TEMPORARY REVISION

AMM-TR-MÄM 42-1178

Improvement of Instrument Panel

CHAPTER 11
PLACARDS AND MARKINGS

Figure 1: Interior Placards and Markings

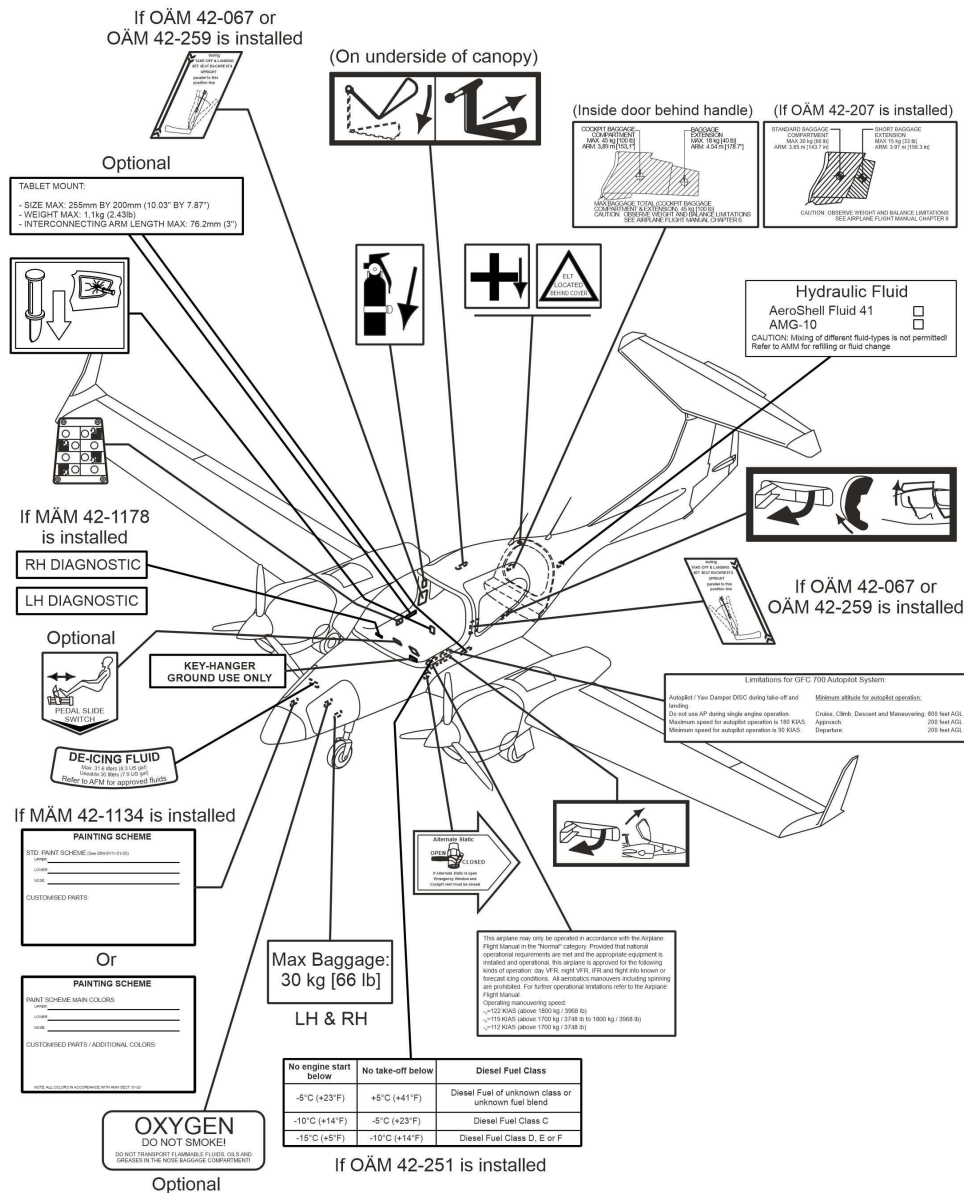
Figure 1 is amended to read:
